RELATED CORRESPONDENCE

In the Matter of
LONG ISLAND LIGHTING COMPANY
(Shoreham Nuclear Power Station, Unit 1)
Docket No. 50-322-1 (OL)

Re: TDI Diesel Generator Owners Group
Request for Additional Information
(C. H. Berlinger to C. L. Ray of October 10, 1984)
File No.: MTS-4086

SUBJECT: REQUEST FOR ADDITIONAL INFORMATION ON FIGURE 3.13 FaAA REPORT
85-3-16, "EVALUATION OF EMERGENCY DIESEL GENERATOR CRANKSHAFTS
AT SHOREHAM AND GRAND GULF NUCLEAR POWER STATIONS"

Figure 3-54. Photograph of the macroetched longitudinal (A1A) section.

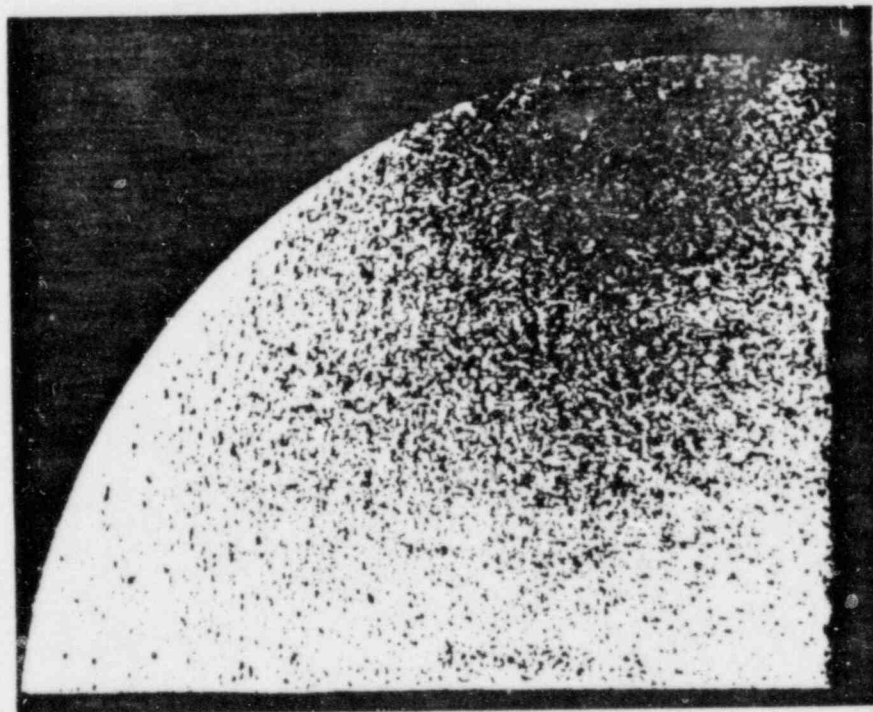
6. Data to validate lack of anisotropy including bases for selection of specimens (e.g., macro-etching to determine flow lines), type, size, locations and testing conditions of specimens.

- 5) No significant variation was observed in the mechanical strength measured using the specimens shown in 4) above. It can also be observed in Figures 3-54, 3-55 and 3-56 that the flow lines changed smoothly from location to location; no laps or sharp directional changes were seen. From these data it was concluded that their mechanical strength was isotropic and uniform in the forged crankshaft.

- 6) In addition to the tension tests described above and the macroetched appearance of the samples shown in Figures 3-54, 3-55 and 3-56, the hardness tests were performed on the same cross sections. The hardness data indicated no significant variations over the entire area of the cut cross sections.
